Preferred Project Report and Response to Submissions

Discovery Point, 1 Princes Highway Wollongong
Residential and Mixed Use Development (MP10_0003)

Submitted to
Department of Planning
On Behalf of Discovery Point Pty Ltd

December 2010 ■ 09642

Figure 6 – Building separation of indicative floor layout (PPR)

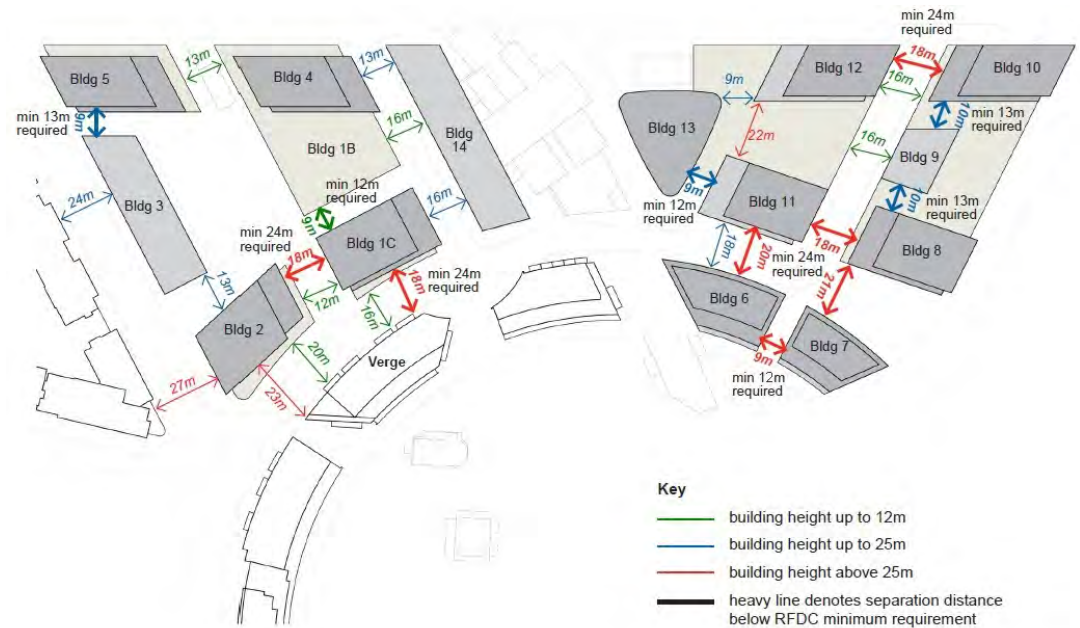
Figure 5 and Figure 6 compare the exhibited Concept Plan to the PPR proposal.

Between Building 6 and 7, the separation distance remains at 9 metres. As the rooms will be non habitable/non habitable no privacy issues arise. As discussed elsewhere in this PPR, there is considered sufficient urban design merit in breaking up the bulk of building 6 and 7, which were approved as a single building mass in the approved Master Plan. The breaking up of the building provides clear site lines and pedestrian linkages from Chisholm Drive through to Discovery Point Park. For these reasons, the separation distance of non habitable/non habitable is considered justified in this instance.

Figure 10 – Cooks River frontage podiums (proposed December 2010)

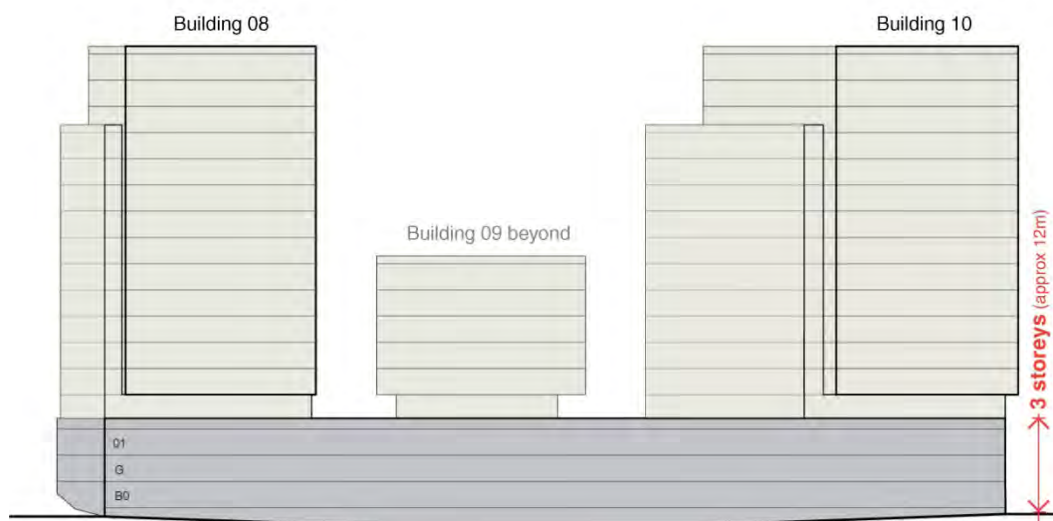
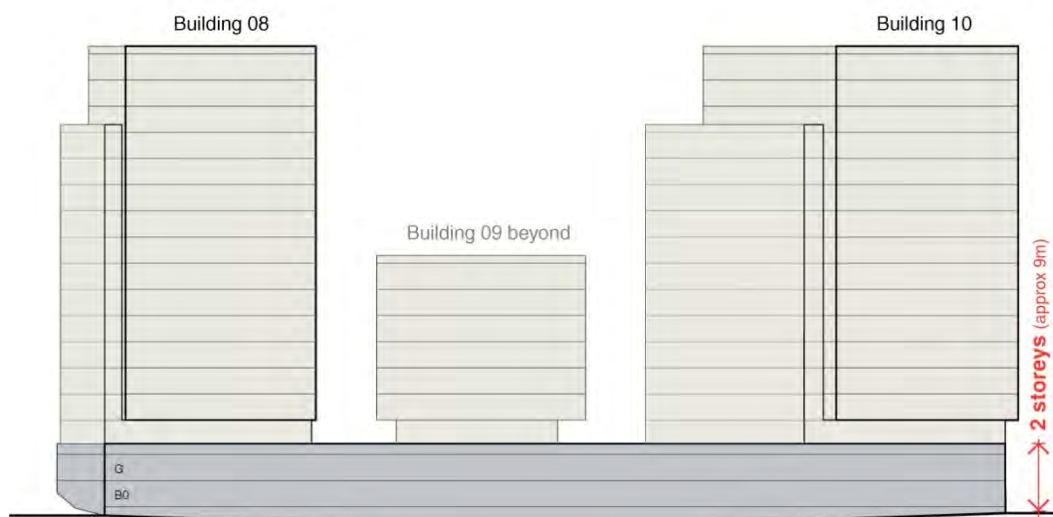
Further to the proponent's meeting with the Department of Planning on 18 November 2010, it was clarified that the principal concern relates to the adjacent above ground parking affecting podium height to Cooks River.

The podium heights adjoining the Cooks River have been revised in the indicative design scheme to address this concern, showing a scheme which has gone from RL14.65 to RL11.6, a reduction of 3.05 metres.

As demonstrated in the above diagrams, the current design reduces the podium levels fronting the Cooks River from the three residential levels (exhibited August 2010) to two residential levels. This represents a significant improvement to the existing DCP 45 (and Master Plan), which allows approximately another 1.5 floors to be placed in the podium. The proponent's response will reduce the apparent bulk of the podiums when viewed from the foreshore. The podium itself will contain residential apartments which will all satisfy the RFDC 2 hour solar access 'Rule of Thumb' (being north facing), will be two storeys to ensure cross ventilation requirements are met and will continue to provide pedestrian connections from the dwellings to the foreshore park.

Figure 11 – Site Orientation

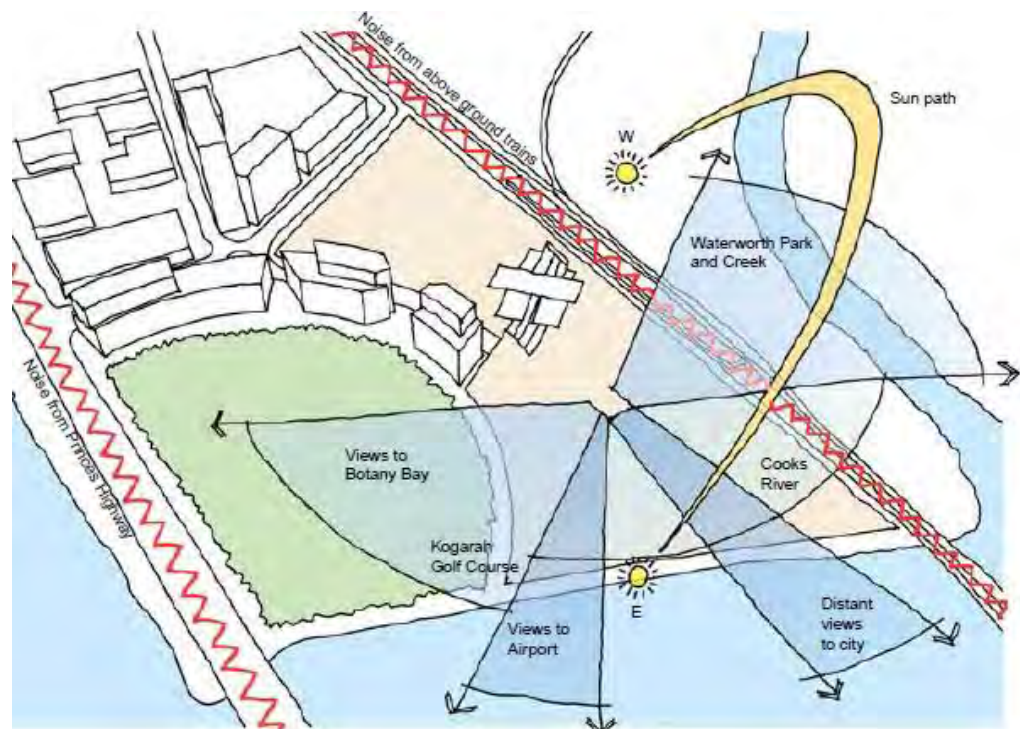
No buildings along the western boundary of the Concept Plan are oriented due west but, as indicated on **Figure 11**, the site is oriented north-west. Thermal comfort will be achieved by means of balcony overhangs, louvers/screens, fixed or operable screening, performance glazing, blinds and insulation. The development will comply with the requirements of BASIX and the BCA.

Figure 14 – Reductions in above ground parking, ground floor level

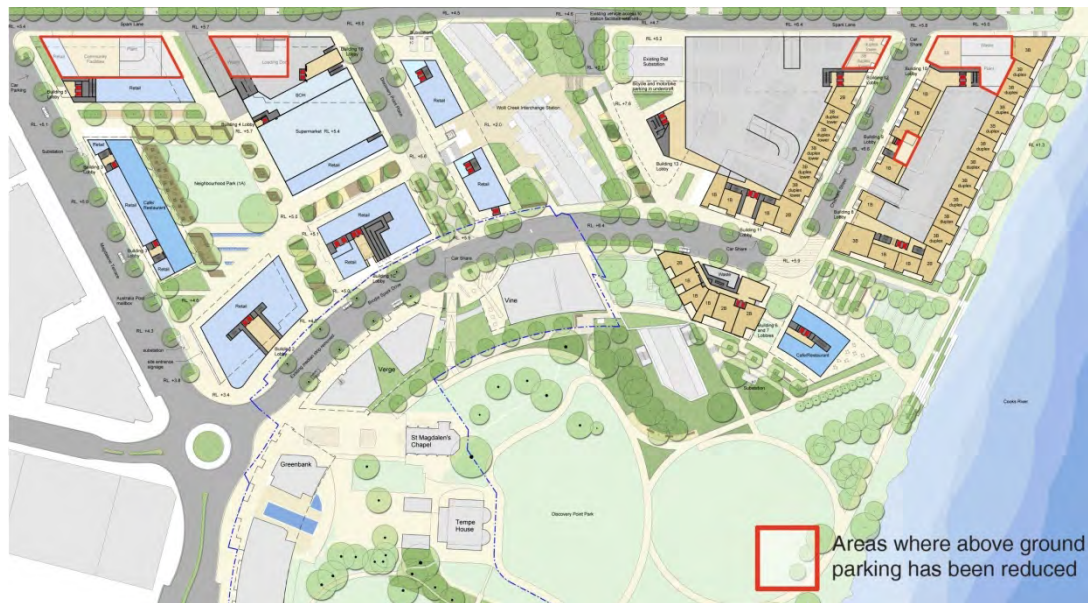
The EAR does not provide adequate justification for the above ground parking. Council's previous approvals on the site and the detailed Master Plan required parking to be provided within basements. The additional floor area (14,000m²) to cater for the above ground parking is considered to impact upon the proposed building envelopes. Further consideration of below ground parking shall be submitted to the Department.

In response to DoP and Rockdale Council concerns regarding the extent of above ground parking, the project team have explored areas where above ground parking can be reduced on the site, with amendments shown in **Table 3** (and shown in **Figure 14 and 15**).

As a result of the above changes, the extent of above ground parking area will be reduced from 14,000m² (as exhibited in the Concept Plan) to 8,000m². In the locations where above ground parking will be provided, appropriate facade treatment or activation via residential or retail development will be provided.

Figure 18 – Spark Lane North Cross Section

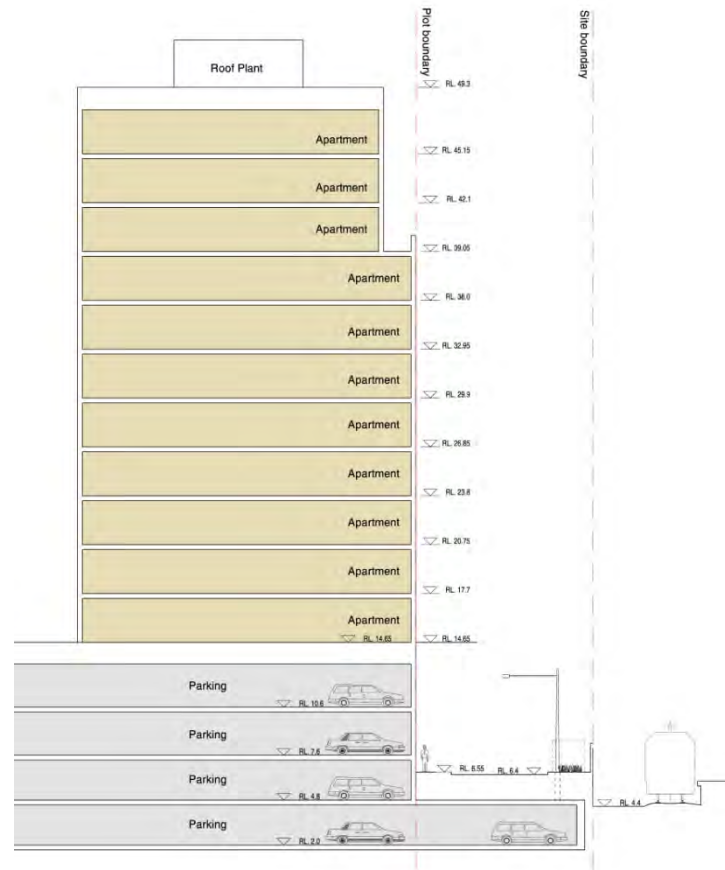
The extent of above ground parking on Spark Lane North is consistent with the 6 Cities approach to provide the extent of above ground parking on laneway access. This approach presents an appropriate design solution as:

- It focuses non-active frontages along Spark Lane, which has the least visual and acoustic amenity for residents or pedestrians due to the proximity to the railway line.

- It remains appropriate to lift residential development above the ground and first floor levels along Spark Lane on the northern side, improving the visual outlook of dwellings which would otherwise look directly onto the railway line (see cross section below).
- Effective screens and landscaping treatments are capable of being incorporated into the detailed design.

Figure 19 – Northern section showing above ground parking is flanked by residential uses

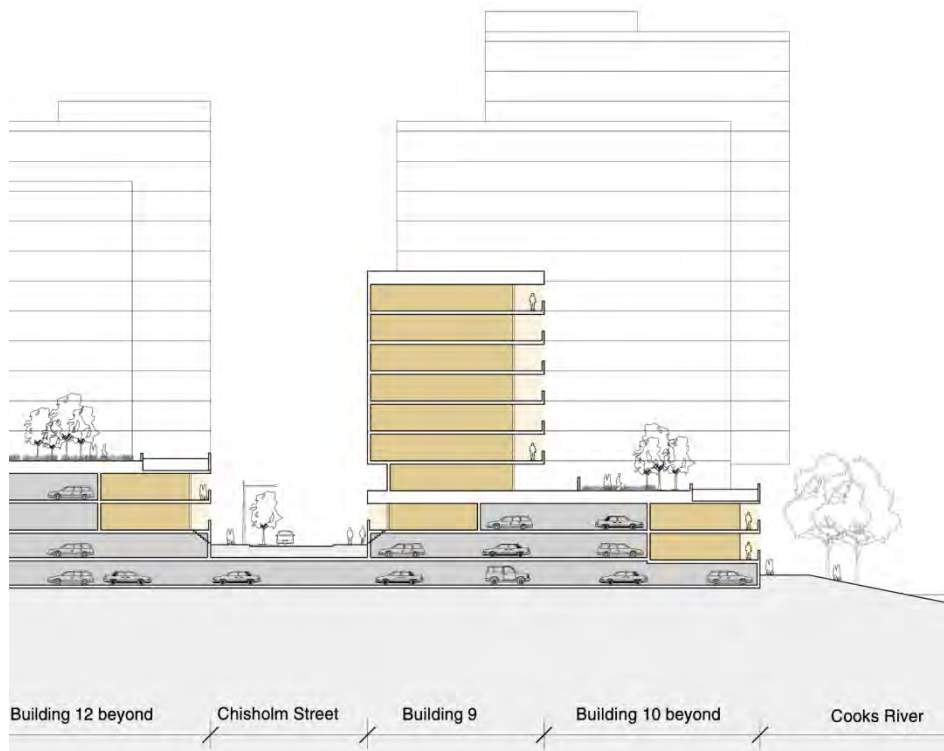
This area of the site clearly demonstrates the effective treatment of above ground parking in accordance with the philosophy of the RFDC by (Figure 19):

- wrapping the above ground parking with residential uses, to ensure active frontages and visual amenity for pedestrians; and
- using the roof of the above ground parking to provide communal outdoor space with outlook towards the Cooks River.

Figure 27 – View from 1404/35B Arncliffe Street (Concept Plan)

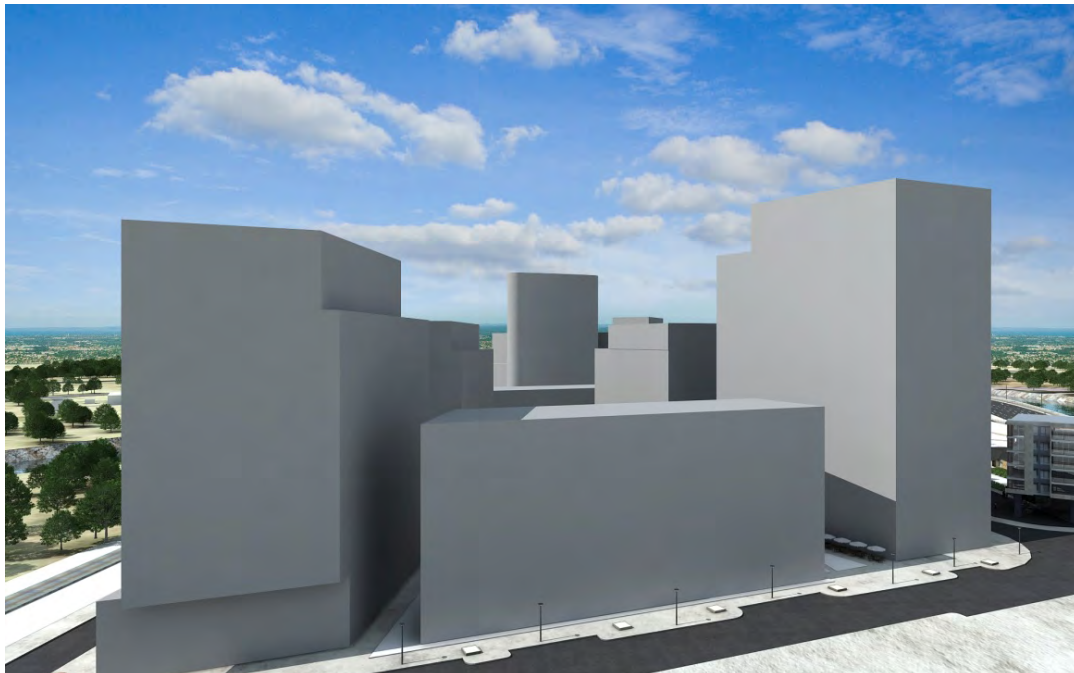
Further view analysis from buildings located to the south of the site are to be provided (in particular from the building of the objectors), to assist in understanding the impact of the proposed building heights on all views. Additional plans (elevation plans) should also be provided that compare the previously approved building heights to that proposed under the Concept Plan from these views.

Figures 26 and Figure 27 (also located at **Appendix F**) provide a comparison of the views available from the submission author's balcony between the approved Master Plan and the proposed Concept. The key conclusion from this analysis is that the Concept Plan has no greater impact on views from the submitter's property than would have resulted from the approved Master Plan.

It is therefore considered that extent of view loss is no worse in relation to views approved under the Master Plan and no amendments to the Concept Plan envelopes are proposed (other than reducing the height of Building 4).
